CITY OF MERCER ISLAND

PLAN NUMBER
 PROJECT
 PREMIUM HOMES
 OF MERCER ISLAND
 2906 74TH AVE SE
 Mercer Island
 WASHINGTON

531510-0836
 SHEET TITLE:
 SITE PLAN
 SHEET NUMBER:
 C-1.0

2906 74TH AVE SE REMODEL

PLAN NUMBER
PROJECT
PREMIUM HOMES OF MERCER ISL REMODEL
2906 7th Ave SE Mercer Island WASHINGTON 98040
531510-0836
SHEET TITLE:
SHEET NUMBER
A-0.2

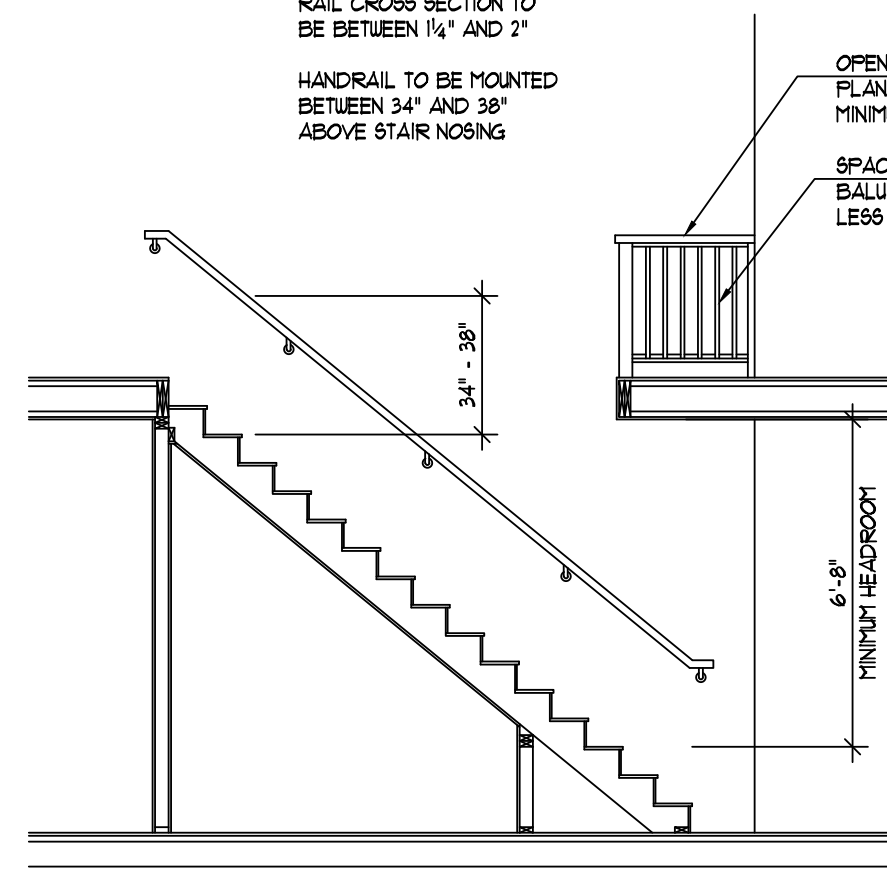
1 **FIRST**
EXISTING ~~BASEMENT~~ FLOOR PLAN
SCALE: 1/4" = 1'-0"

1 ROOF PLAN
 1/4" = 1'-0"

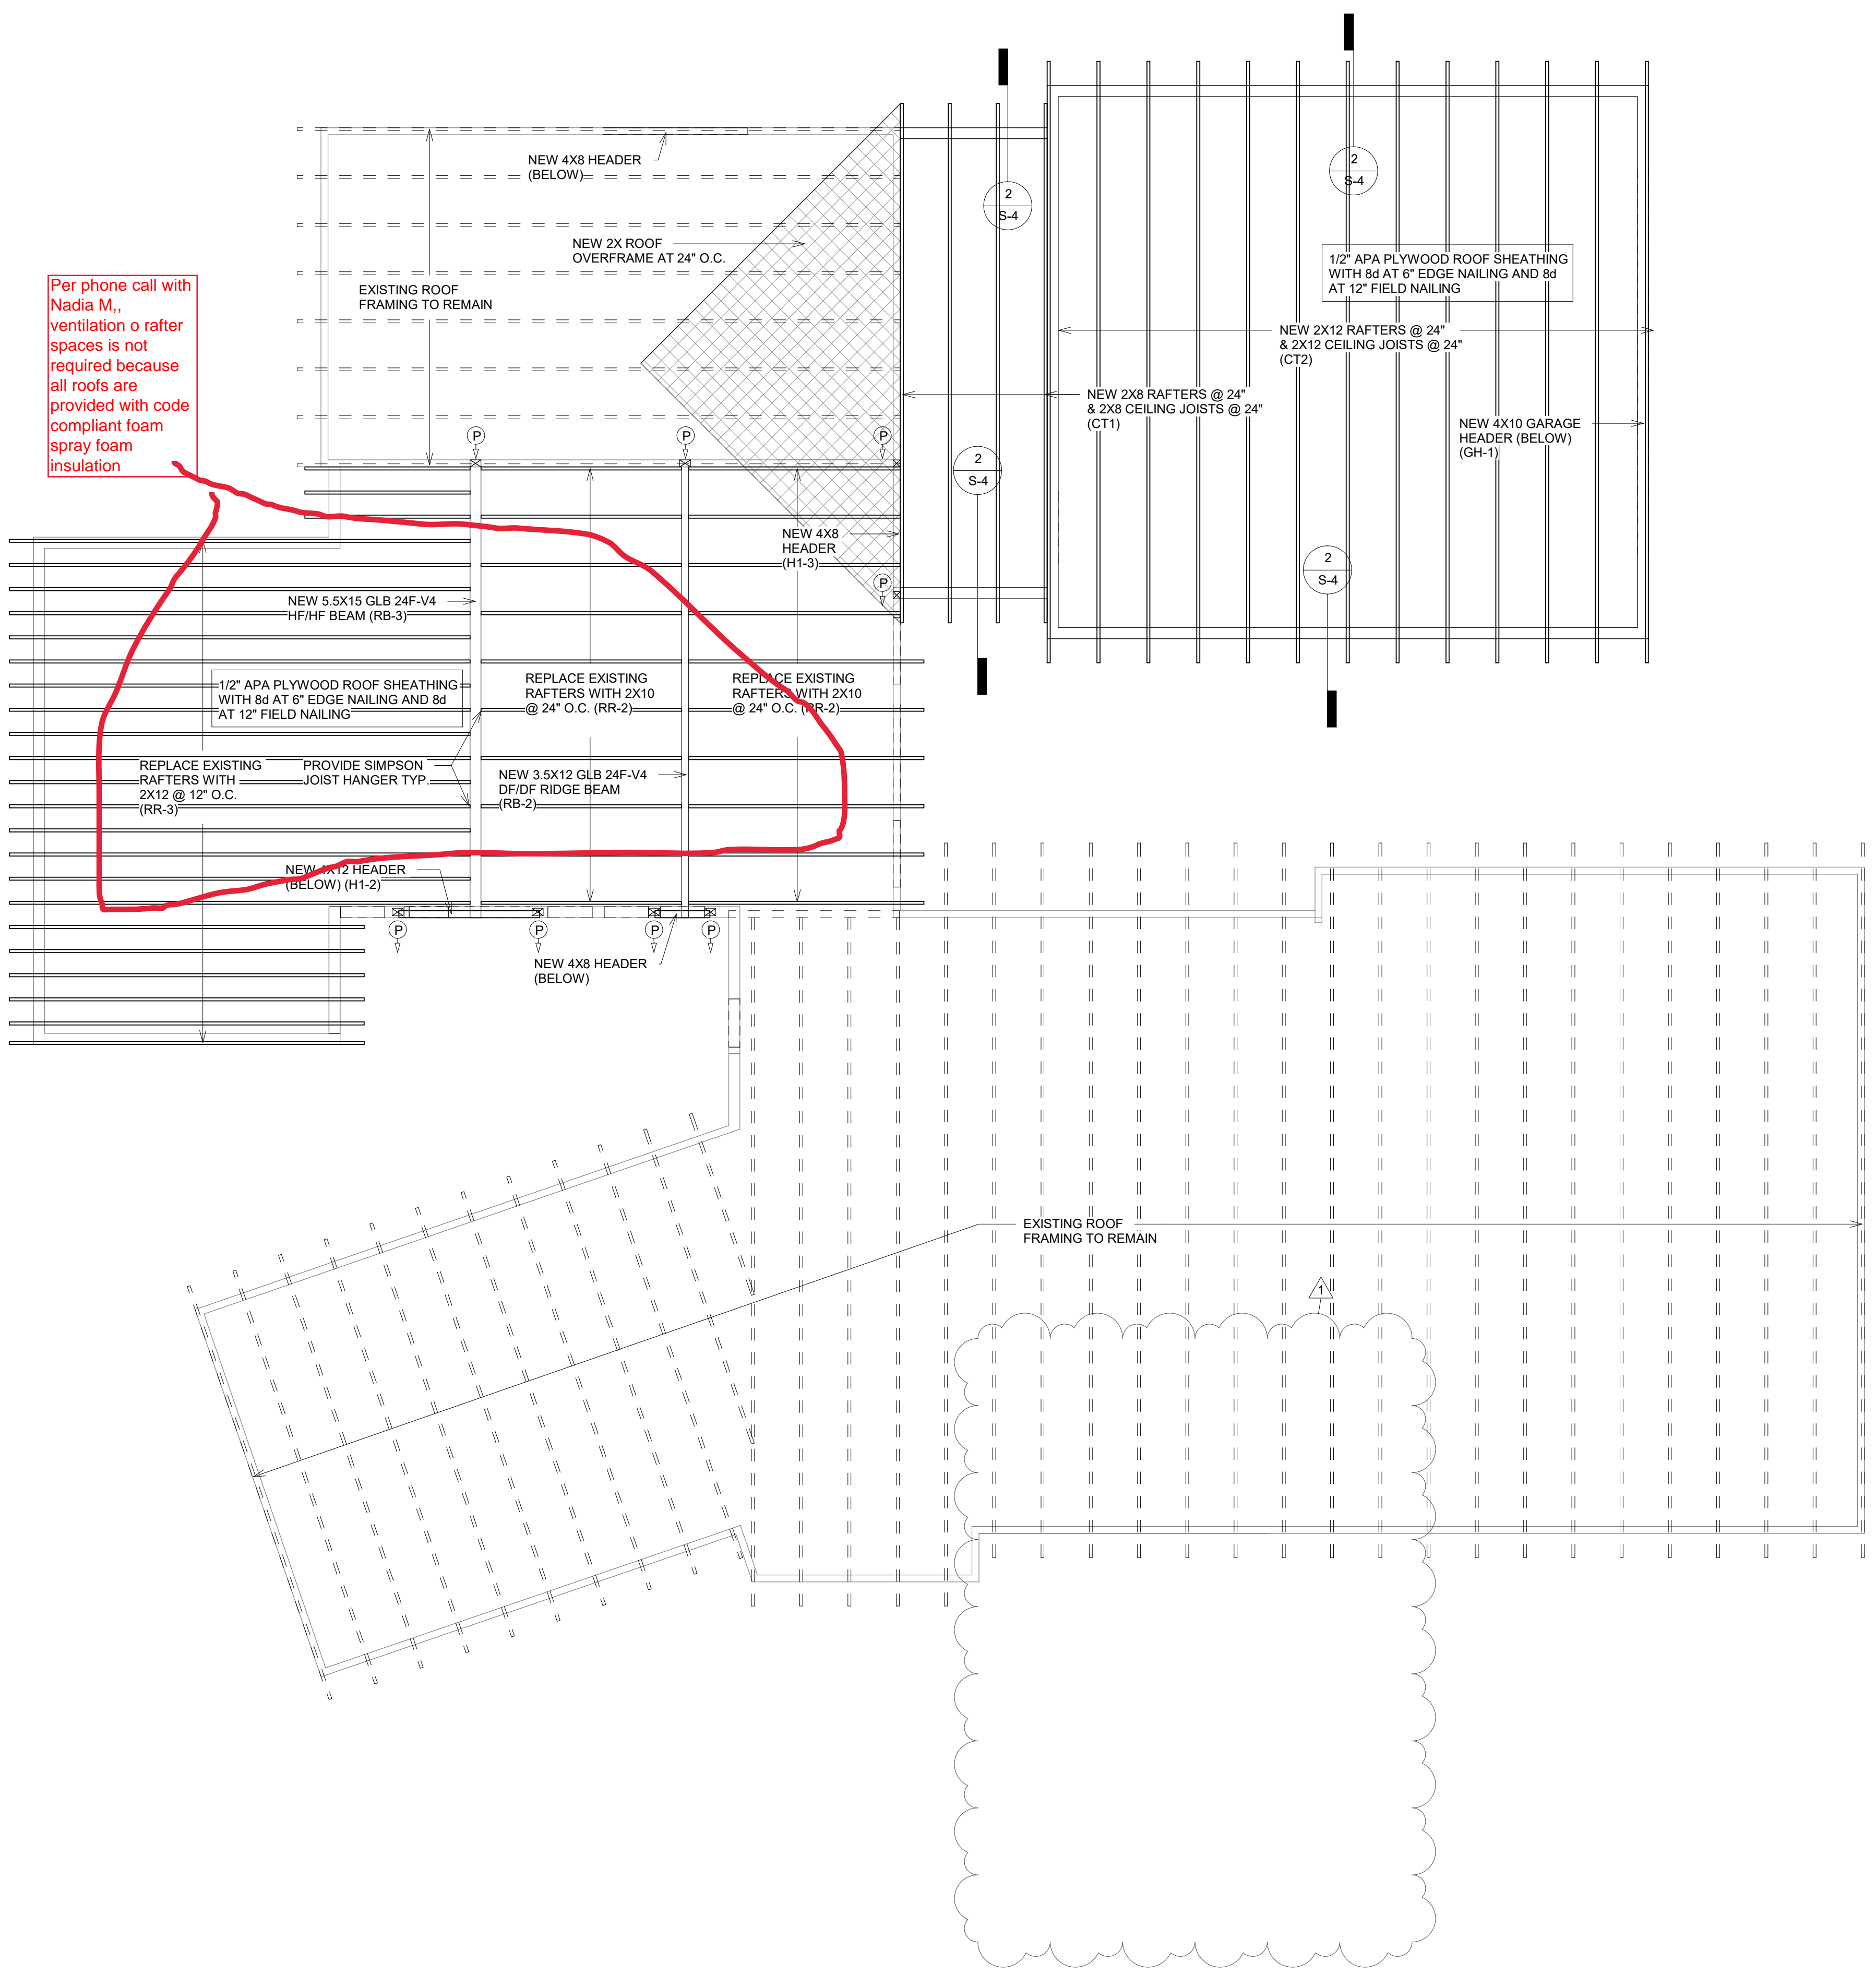
Per phone call with Nadia M., ventilation or rafter spaces is not required because all roofs are provided with code compliant foam spray foam insulation
